Proposed Temporary Warehouse for Storage of Vehicle Parts and
Construction Materials for a Period of 3 Years

Lots 1979 S.A, 1979 RP, 1980 (Part), 1981 (Part) & 1982 (Part) in D.D. 129,
Lau Fau Shan, Yuen Long, N.T.

TPB Ref.: A/YL-LFS/445

Proposed Temporary Warehouse for Storage of Vehicle Parts and Construction Materials for a Period of 3 Years at Lots 1979 S.A, 1979 RP, 1980 (Part), 1981 (Part) & 1982 (Part) in D.D. 129, Lau Fau Shan, Yuen Long, N.T.

Figure 3

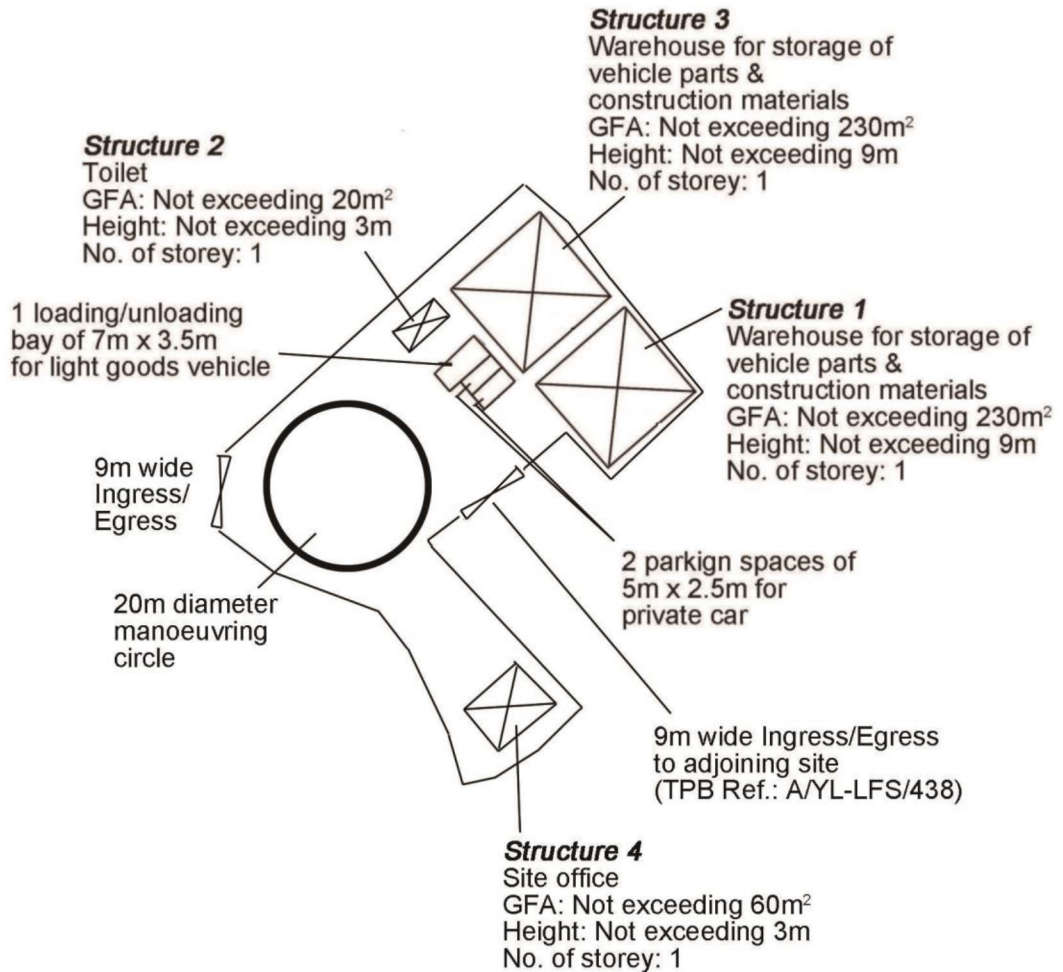
We write to provide the updated Figure 3 (proposed layout plan), Figure 6 (Tree Location in D.D.129) and Annex 1 for your further processing of the Captioned application.

Figure 3

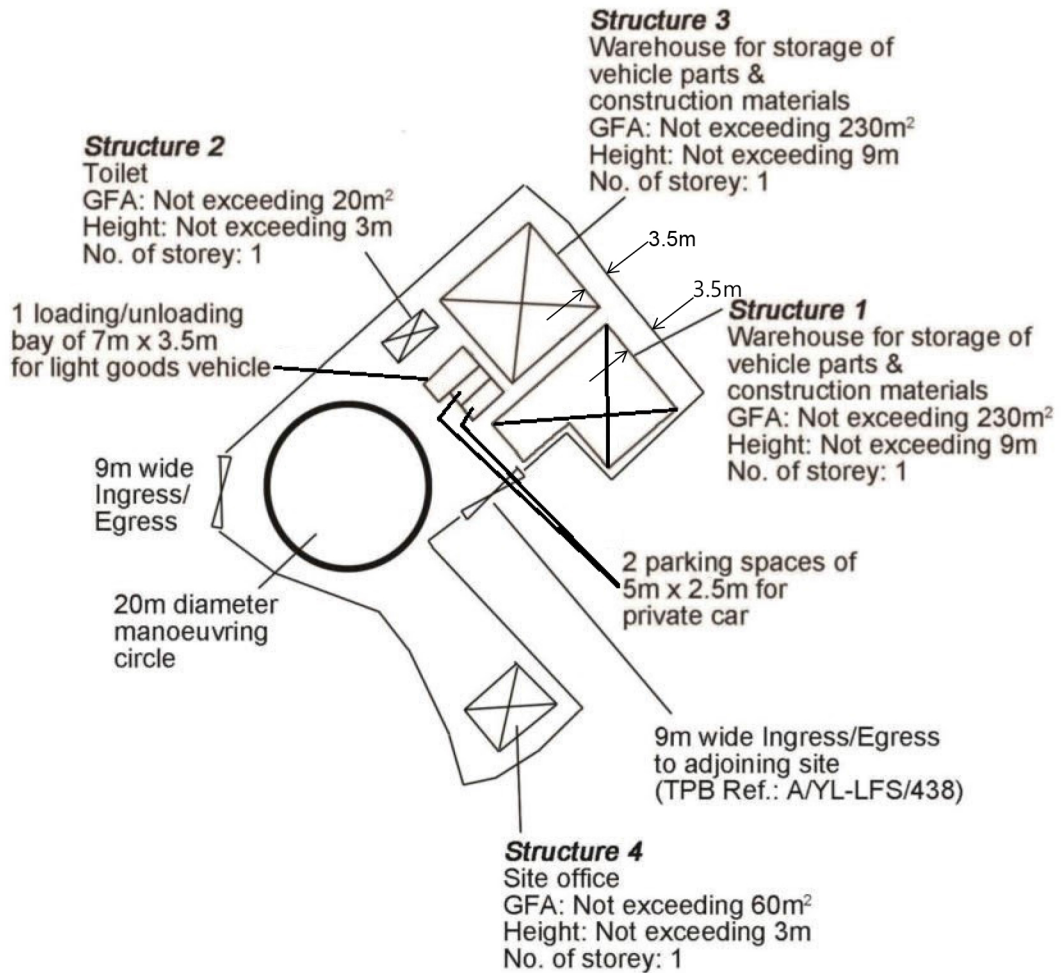
In response to the comments of the GEO, we have updated the proposed layout plan (Figure 3) and proposed landscape plan (Figure 5) for her comments.
